FENCE AND WALL DETAILS
WESTERN CANAL

5. SUBJECT: Award Agreement ST9-913-2749 for Block Wall – Repair & Replacement to Dean Fence & Gate, Inc. dba Dean Masonry Construction in an amount not to exceed $404,551.72.

CITY OF CHANDLER SERVICES AGREEMENT
BLOCK WALL – REPAIR & REPLACEMENT
AGREEMENT NO.: ST9-913-2749

CITY OF CHANDLER, ARIZONA
WESTERN CANAL DRAINAGE AND SITE IMPROVEMENTS

MASONRY WALL WITH FENCE
FOR CITY OWNED WALLS ONLY

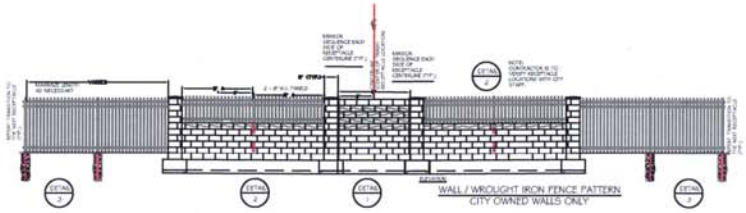
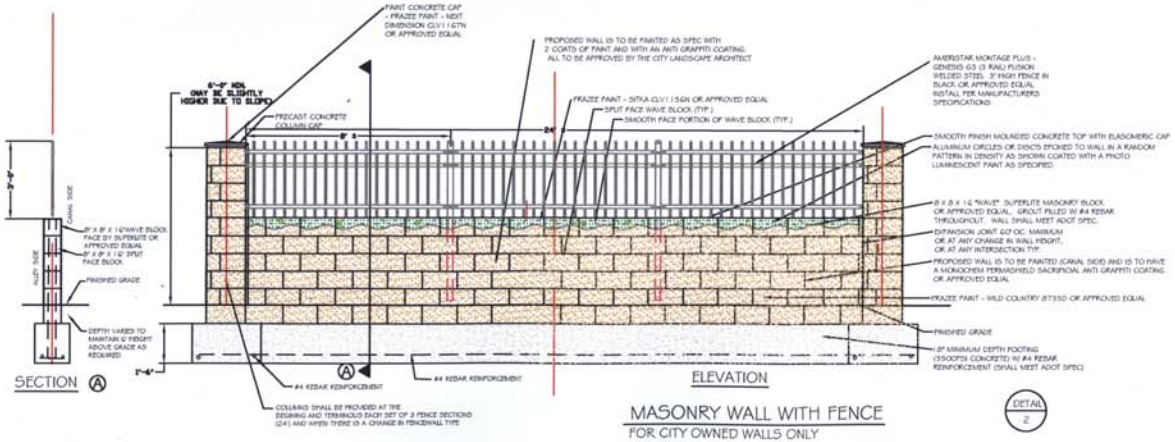
1. **Question:** How many horizontal rebar are required in the continuous footing. What is the spacing on the vertical rebar and what size lap is required? Will there need to be extra vertical rebar at the construction joints and at the end of the walls. **Answer:** Arizona Department of Transportation specifications for this project is detailed by ADOT, Inter-model Transportation Division #SD 8.02 1 and 2 of 2 for sound barrier walls (masonry). This is most current revision and clearly states the wall technical specifications.

2. **Question:** What diameter is the post footing for the wrought iron required to be? Will there be wall elevations distributed in the plans for future reference? **Answer:** The auger width for the post footing shall be 8" and the depth shall be 36". The wall is to be 6' in height. Elevation changes will be handled at columns to raise and/or lower the wall as required due to existing grades.

SITE PLAN
WESTERN CANAL SITE UPGRADES

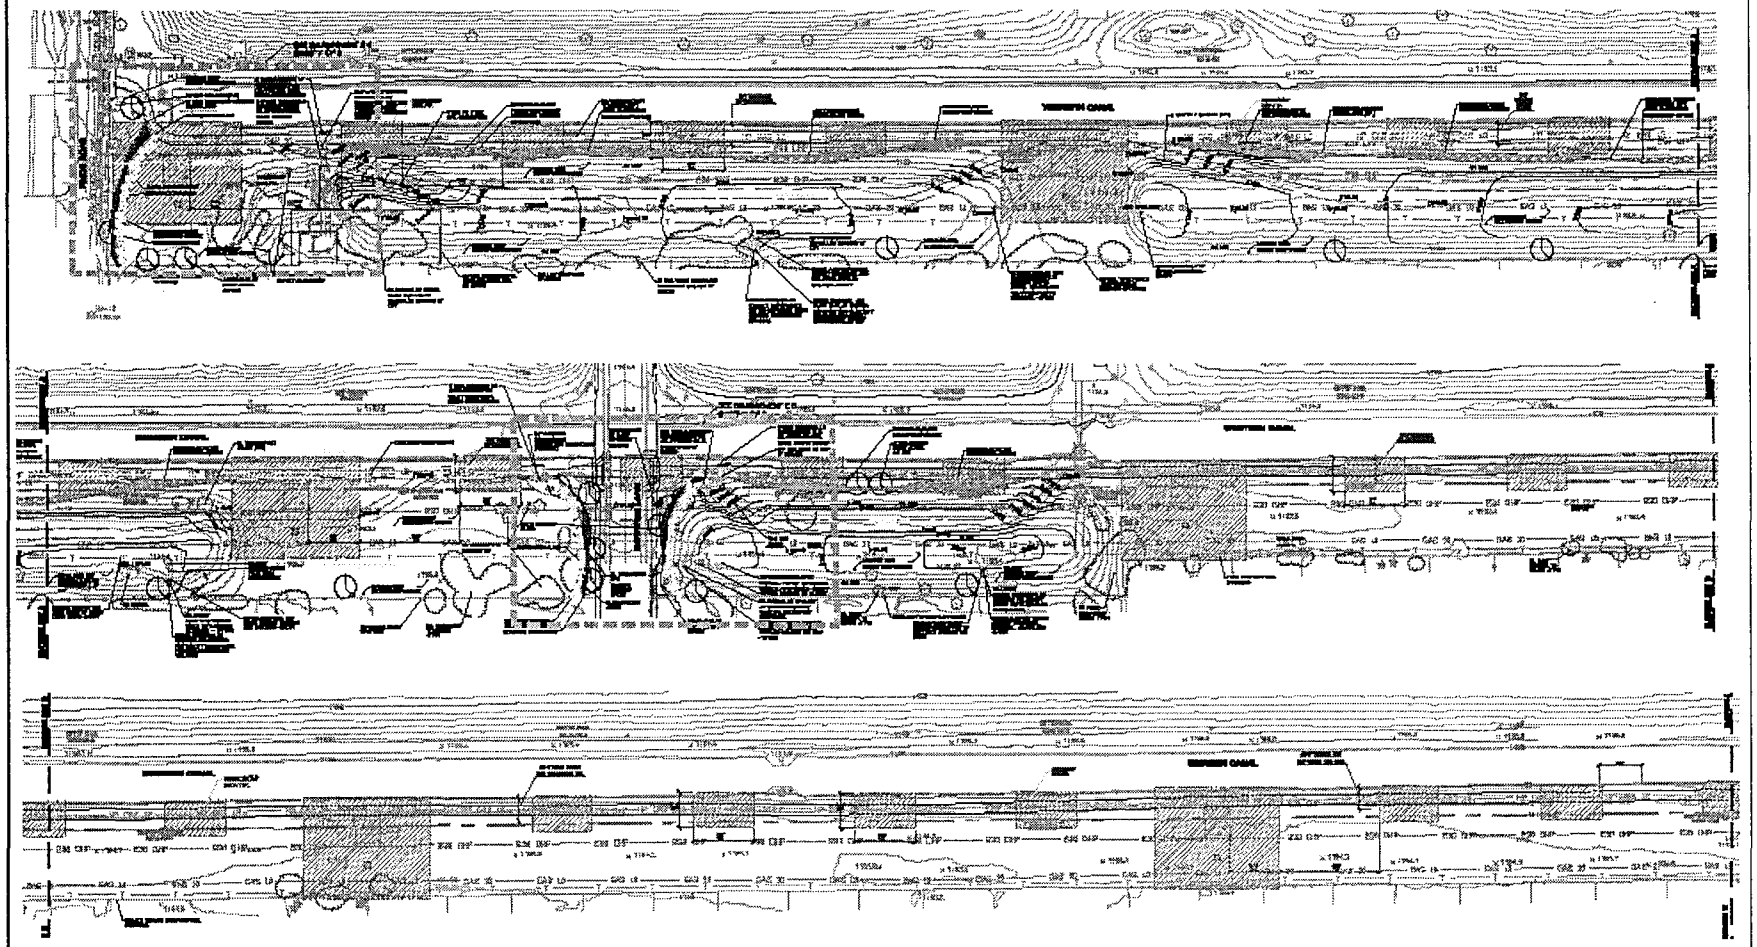
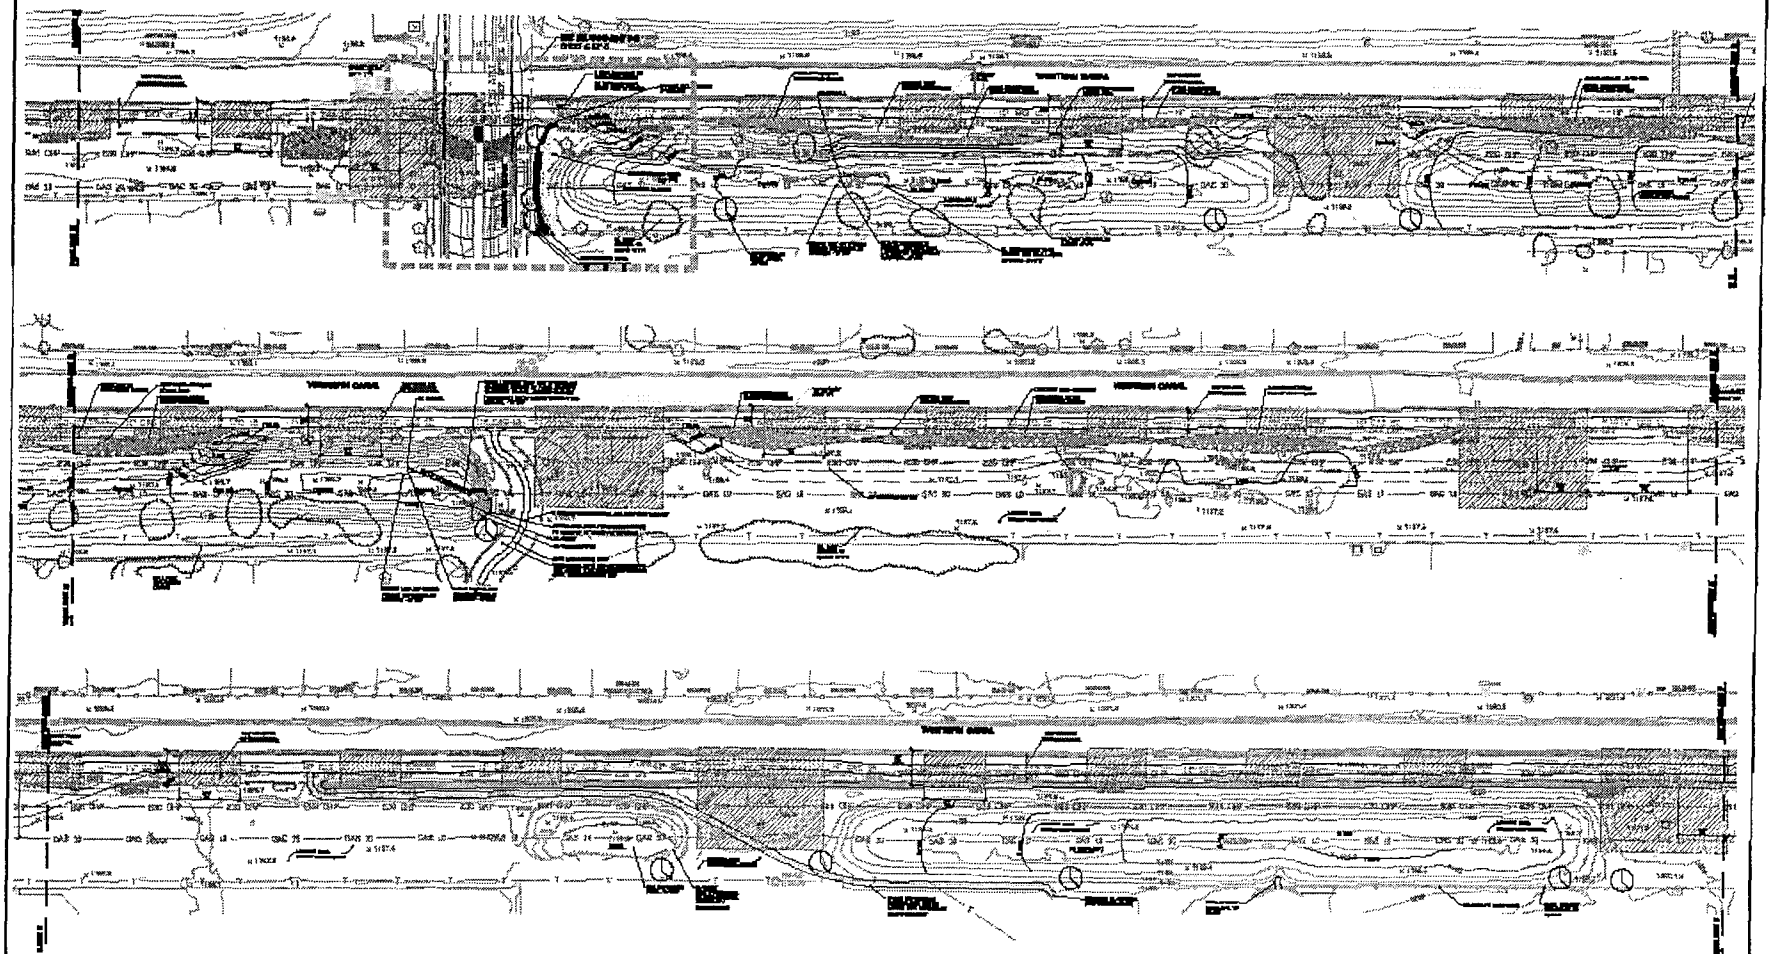
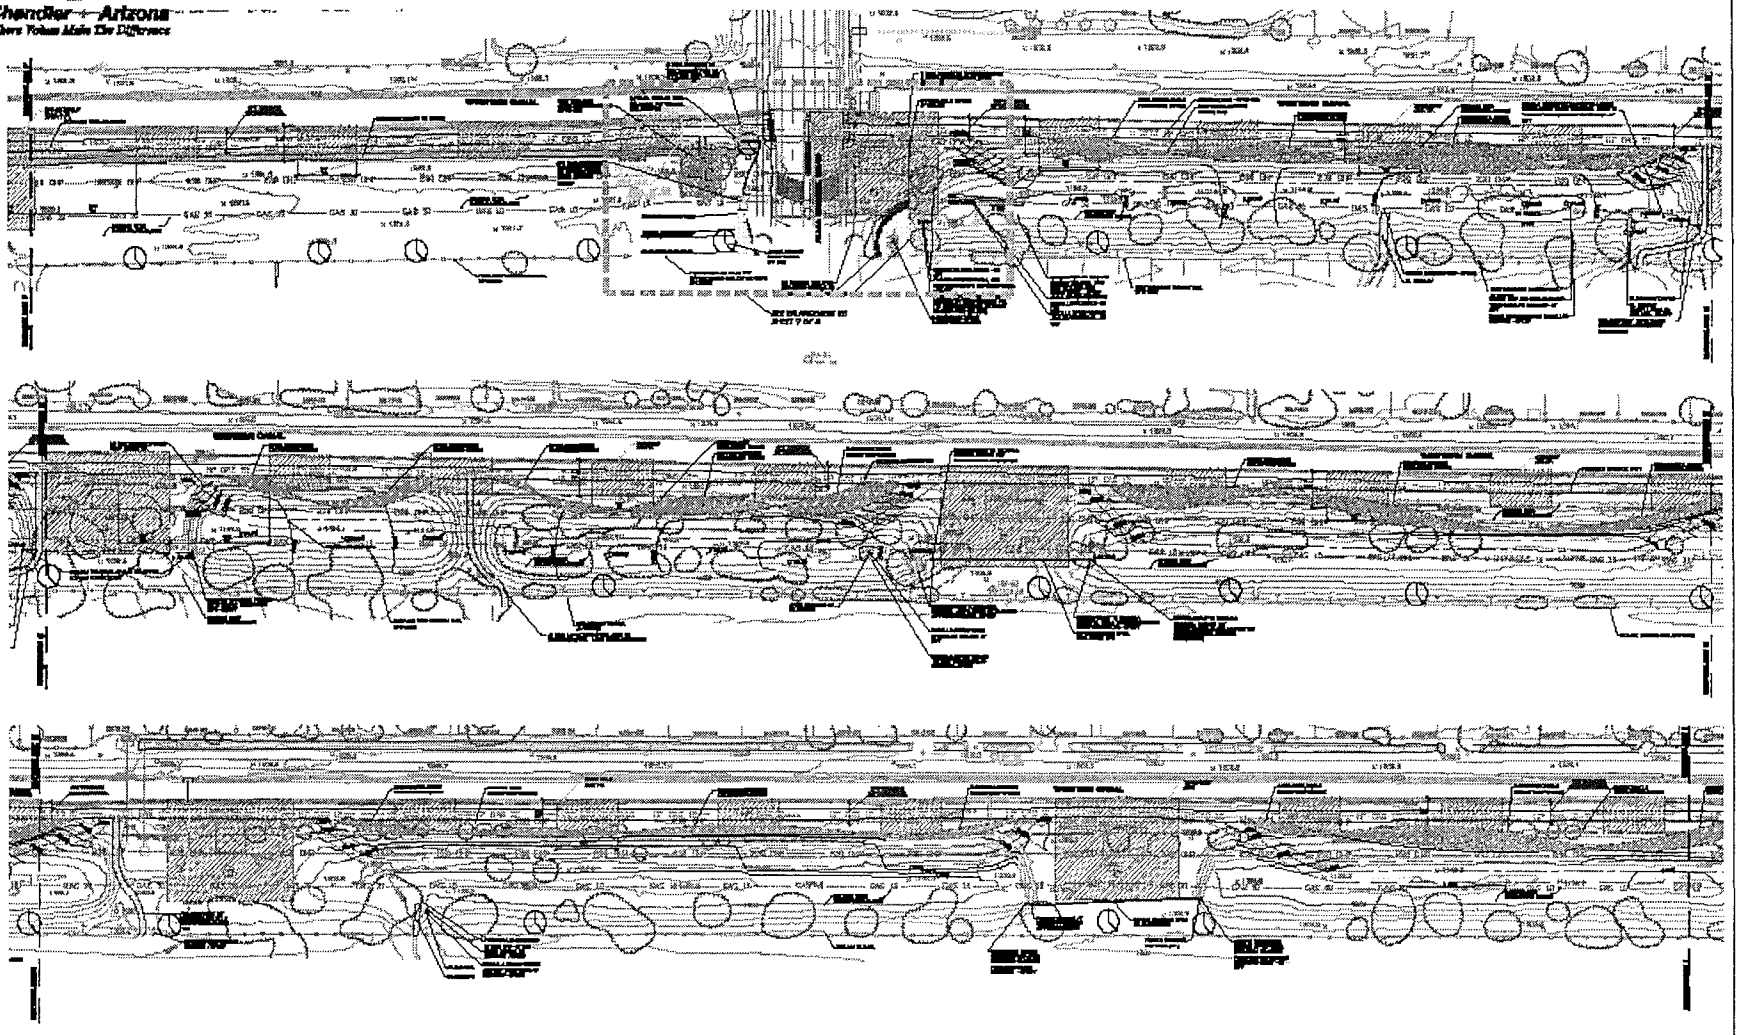
3. Trash receptacle locations have been added to the plan for the City-owned wall between Arizona Avenue and Alms School Rd. This area is also to receive the Wall/Wrought iron Fence Pattern as specified.

4. Additional wrought iron fencing and gates have been added to the scope of work. (See attached revised plans for locations). These locations are adjacent to Price Road, Carriage Land, the east side of Dobson Rd, and the west side of Alma School Rd. Matching wrought iron gates are also proposed on the east side of Alma School Rd, and the west side of Arizona Avenue to like up the recently installed existing fencing and extend the matching style over the pathway itself. It shall be noted that this work needs the approval of Salt River Project (SRP) and some coordination for grounding as well as SRP access at the proposed gate locations will be required.
